Access Compliance Report

Public Rights-of-Way

(Curb Ramps)

Intersection ID: 14311	Main Street: BERKELEY_AV	Cross Street: CARLTON_AV	Location: SW
ADA ID: 7912F253C69A	Ramp Type: Perp	Initial Pass/Fail: Fail	Overall Compliance: No
Severity Score: 12.5			
Codes/Mitigation Info/Possible Solution		Field Measurements/Component Compliance

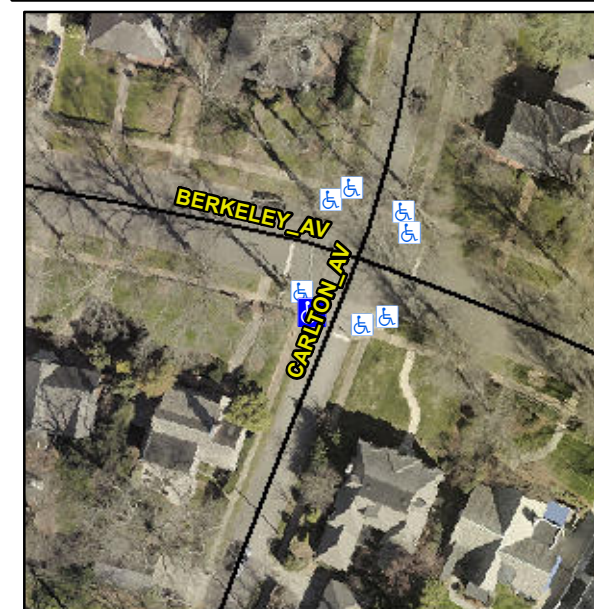
Not Found, R304.2.2

Compliance	Description	Data	Compliance	Description	Data
N/A	Ramp Length (in)	62.0	No	Ramp Slope (%)	8.5
Yes	Ramp Width (in)	60.0	Yes	Ramp XSlope (%)	0.9
N/A	Flare Type LT	N/A	N/A	Flare Type RT	N/A
N/A	Flare Slope LT (%)	N/A	N/A	Flare Slope RT (%)	N/A
N/A	Flare Traversable LT?	N/A	N/A	Flare Traversable RT?	N/A
N/A	Landing Length (in)	N/A	N/A	DWS Provided?	N/A
N/A	Landing Width (in)	N/A	N/A	DWS Contrast?	N/A
N/A	Landing Slope (%)	N/A	N/A	DWS Length (in)	N/A
N/A	Landing X Slope (%)	N/A	N/A	DWS Full Width?	N/A
N/A	Landing Curb? (Y/N)	N/A	N/A	DWS Offset (in)	N/A
N/A	Shared Landing?	N/A			
N/A	Gutter Ponding?	N/A	N/A	Gutter Slope (%)	N/A
N/A	Gutter Lip Ht (in)	N/A	N/A	Gutter X Slope (%)	N/A
N/A	Painted X Walk1?	No	N/A	Painted X Walk2?	N/A
	X Walk 1 Direction	To SE		X Walk 2 Direction	N/A
N/A	X Walk 1 Width (in)	N/A	N/A	X Walk 2 Width (in)	N/A
	X Walk 1 Slope (%)	2.0		X Walk 2 Slope (%)	N/A
	X Walk 1 X Slope (%)	3.0		X Walk 2 X Slope (%)	N/A

Remove & Replace Entire Ramp.
